Southwest Transitway DEIS Comments

Comments Received from Agencies and Other Public Entities

Part 4 of 4

DATE: December 10, 2012
TO: Federal Transit Administration, Region V
FROM: Hennepin County Regional Railroad Authority
Debra Brisk, Deputy Executive Director 
SUBJECT: Southwest Transitway Draft Environmental Impact Statement
Questions and Responses for Surface Transportation Board

Figure 1. Relocation Alternative
MN&S Spur

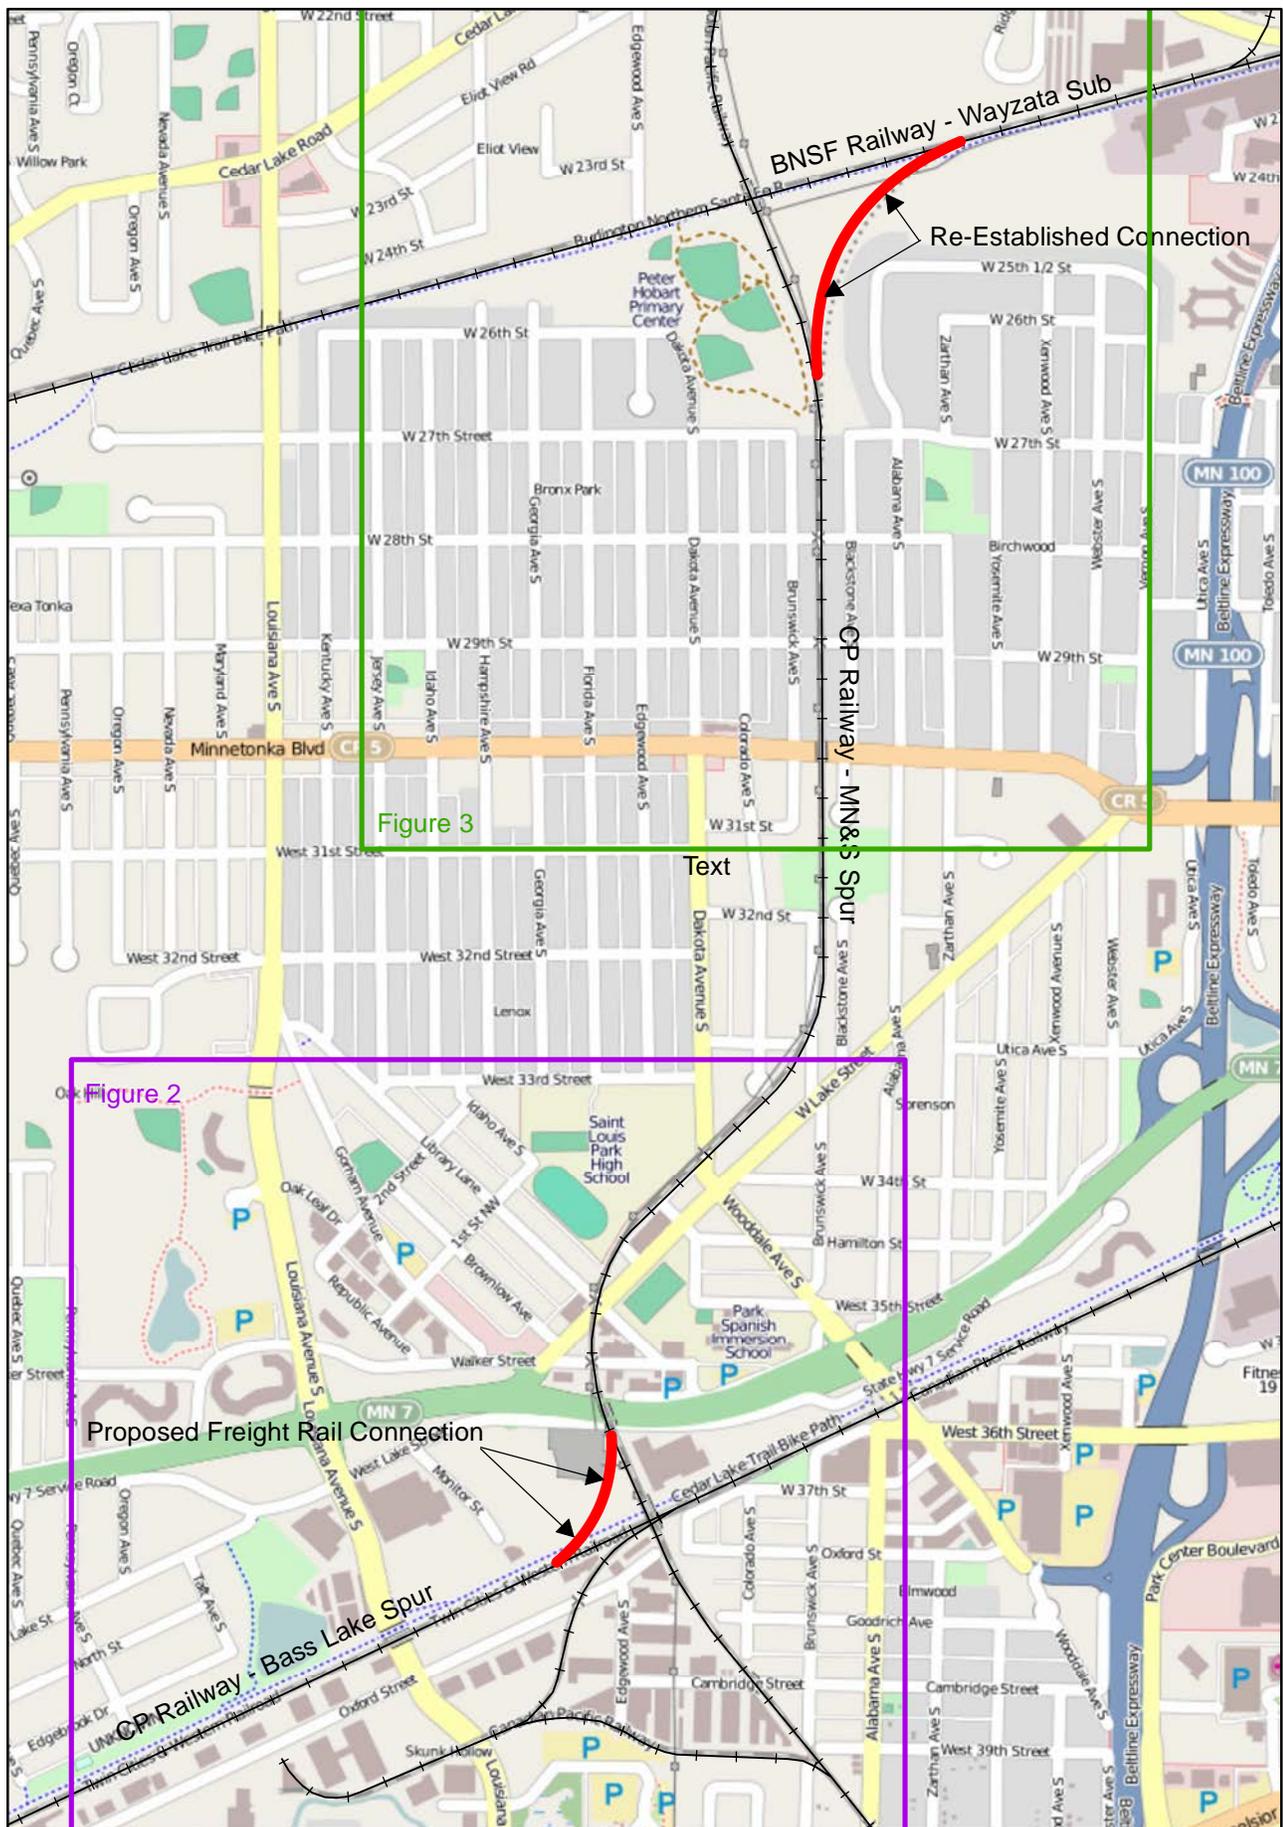
14. *Please provide a map of the existing freight lines/routes (with names to indicate which rail line is which), and a more detailed map that shows the rail lines that freight would be rerouted over. [The map should show street names and any switching track or connection(s) needed on the MN&S and/or Wayzata lines in order to implement the reroute of freight traffic.]*

RESPONSE: See Figure 2.3-1 of the Southwest Transitway DEIS. The attached Figure 1 provides a closer view of the location of the MN&S Spur and Wayzata Subdivision, including the requested information.

Figure 2. Relocation Alternative
 Skunk Hollow Wye Track and
 New Connection - Bass Lake Spur to MN&S Spur

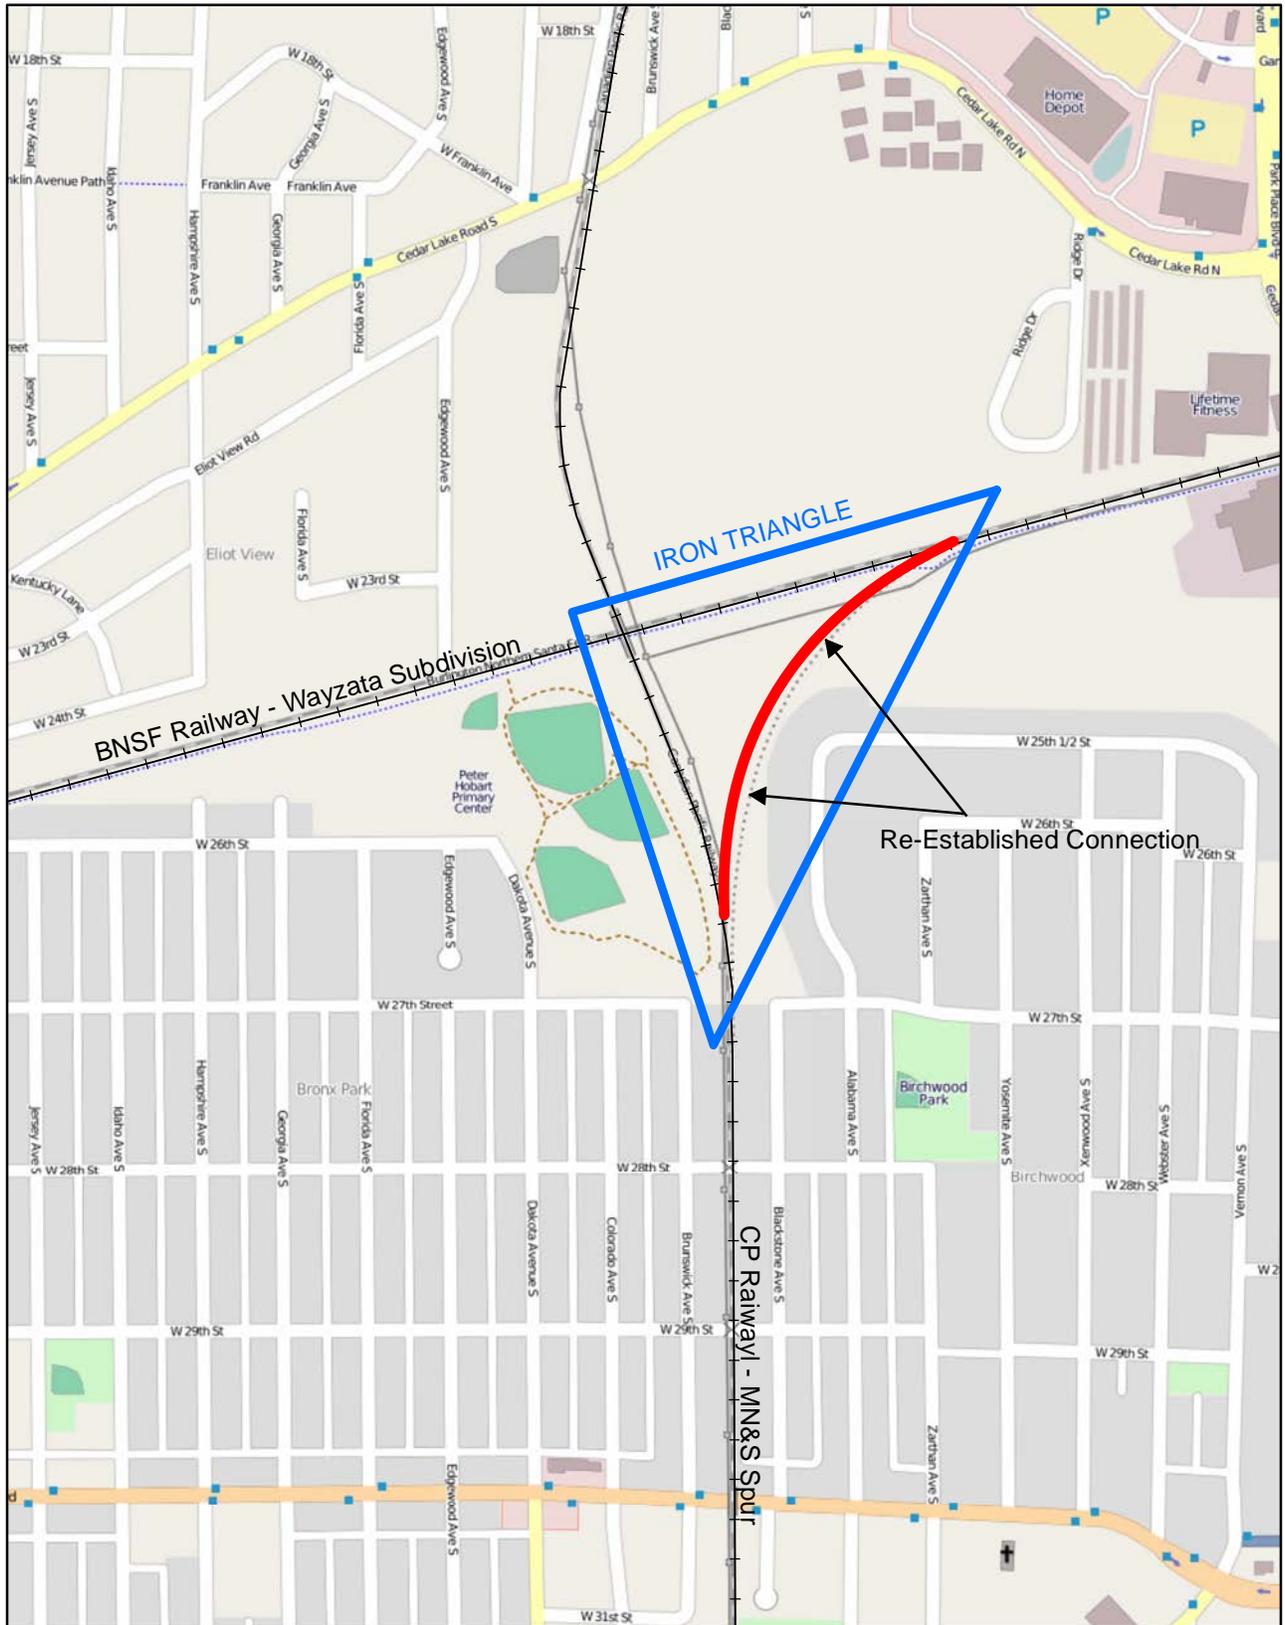
7. *Provide a more specific description of the location of the connection?*

RESPONSE: As seen in the attached Figure 2, the connection will be located in the northwest quadrant where the MN&S Spur crosses over the Bass Lake Spur on a bridge.
